## Service Bulletin

**SB** 21-7  
6/15/88

PRODUCTION CHANGE /  
SCHEDA INTRODUZIONE VARIANTE

SUBJECT / OGGETTO: CLUTCH ASSEMBLY  
VEHICLES / VETTURE TIPO: TESTAROSSA

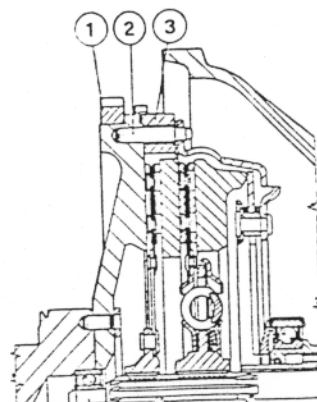
A new clutch unit which differs from the preceding unit in the centering on the flywheel by means of 3 studs is fitted. The new unit can also be fitted to preceding cars if the engine flywheel is also replaced. Cars with C.N. 73701-73735-73737-73791-73793-73873, all in the SWISS VERSION, are still fitted with the premodification units.

Unit improvement.

NOTE: This new unit must be only used to solve eventual vibration problems.
